**STAFF REPORT**  
**COMMUNITY DEVELOPMENT DEPARTMENT**

HEARING DATE: March 9, 2021  
 TO: Mayor & City Council  
 FROM: Sonya Allen, Associate Planner  
 208-884-5533  
 SUBJECT: H-2020-0117  
 Shafer View Terrace – AZ, PP  
 LOCATION: East side of S. Meridian Rd./SH 69,  
 midway between E. Amity Rd. and E.  
 Lake Hazel Rd., in the SW ¼ of Section  
 31, T.3N., R.1E. (Parcels #R7824220044  
 & #R7824220042)

Annexation of a total of 40.48 acres of land with R-2 (10.66 acres) and R-4 (29.82 acres) zoning districts; and Preliminary Plat consisting of 50 buildable lots and 10 common lots on 39.01 acres of land in the R-2 and R-4 zoning districts.

C. Landscape Plan (date: ~~5/17/2020~~ 2/3/2020)

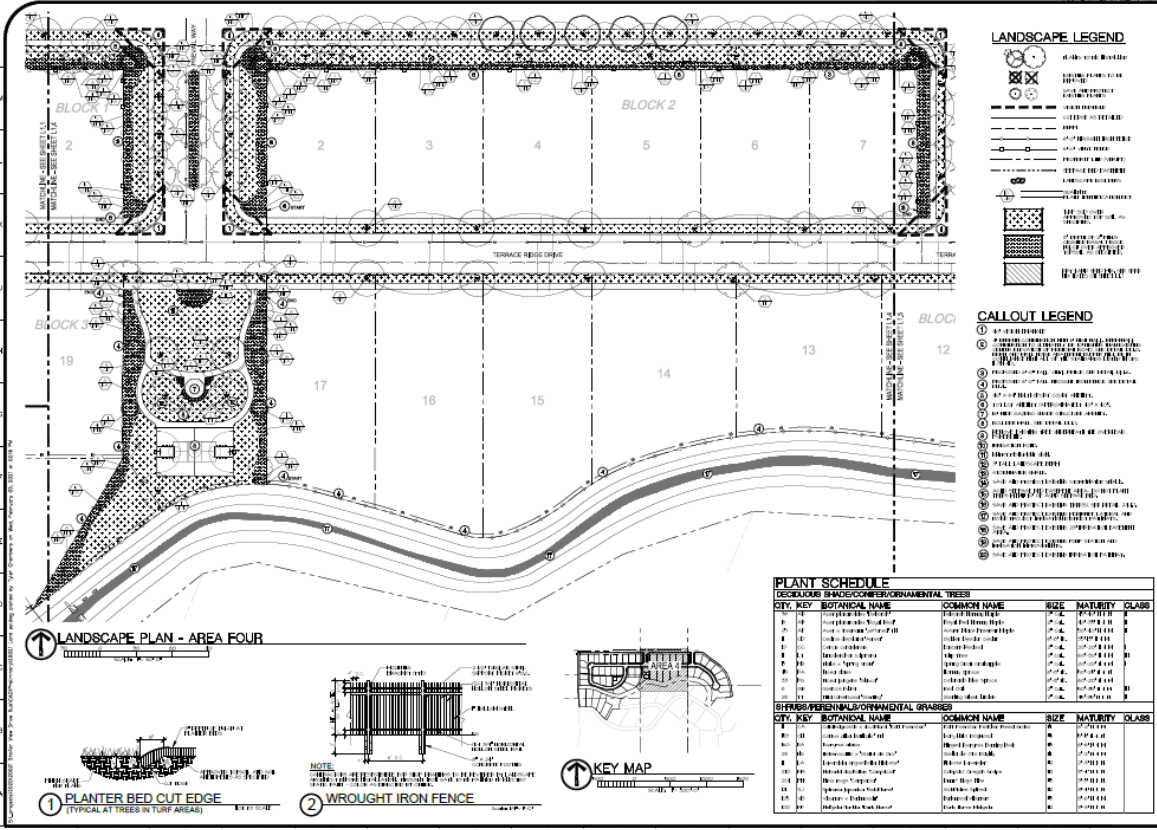
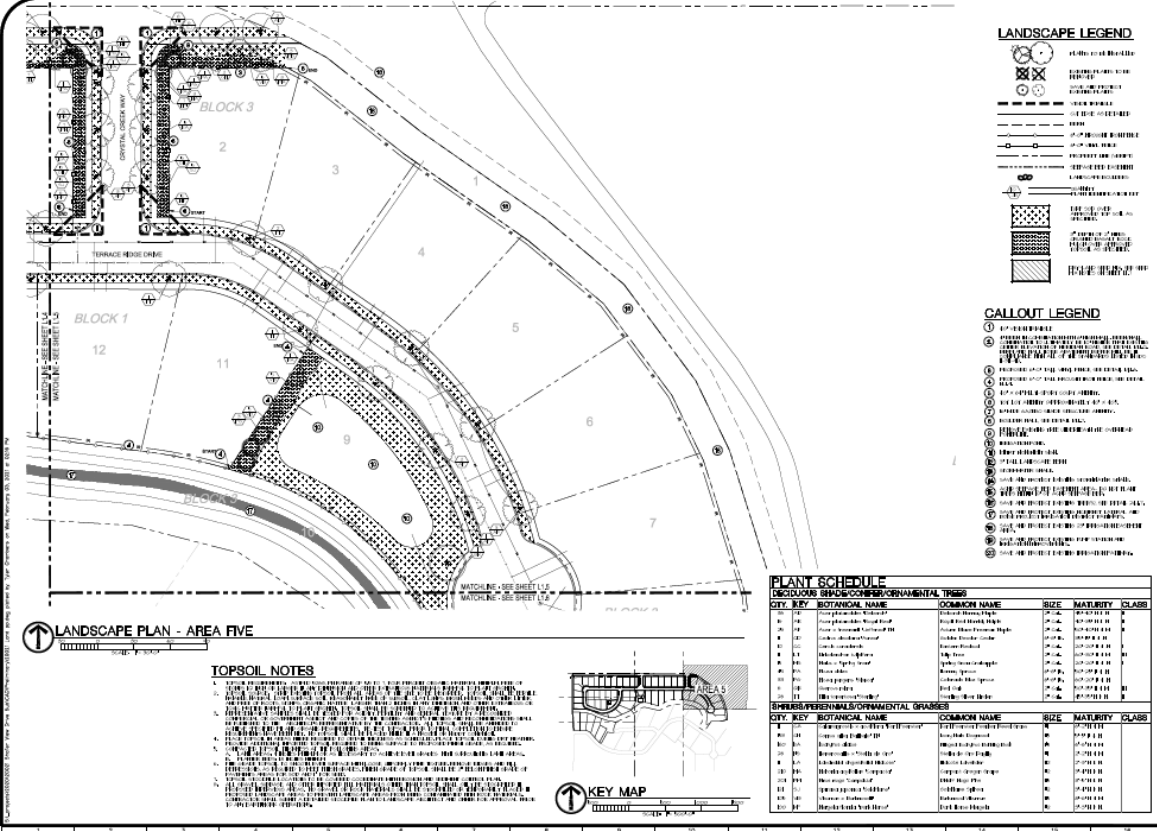
Landscaping is required adjacent to the pathway along S. Meridian Rd./SH-69 per the standards in UDC [11-3B-12C](#). A 5' wide landscape strip is required on both sides of the pathway planted with a *mix* of trees, shrubs, lawn and/or other vegetative ground cover. **The Landscape**

**Requirements table should include the linear feet of pathway with the required vs. proposed number of trees to demonstrate compliance with UDC standards.**

Landscaping is required within parkways per the standards listed in UDC [11-3A-17](#) and [11-3B-7C](#). **The Landscape Requirements table should include the linear feet of parkways within the development with the required vs. proposed number of trees to demonstrate compliance with UDC standards.**

A 4-foot tall berm with a 6-foot tall solid wall by Simtek is proposed along S. Meridian Rd. as noise abatement as depicted on the detail on Sheet L1.0 of the Landscape Plan. Architectural elements are proposed to break up monotonous wall planes as required. ~~**A detail of the proposed wall that demonstrates compliance with the standards listed in UDC 11-3H-4D should be submitted with the final plat for the first phase of development.**~~ *Depicted on the revised landscape plan.*

4. The landscape plan included in Section VII.C ~~submitted with the final plat~~ shall be revised as follows:
    - a. ~~Include calculations in the Landscape Requirements table that demonstrate compliance with the standards for pathway (11-3B-12C) and parkway (11-3B-7C) landscaping; include required vs. provided number of trees. Done~~

- c. ~~Include a detail of the berm and wall required for noise abatement along S. Meridian Rd./SH-69 that demonstrates compliance with the standards listed in UDC 11-3H-4D. Done~~
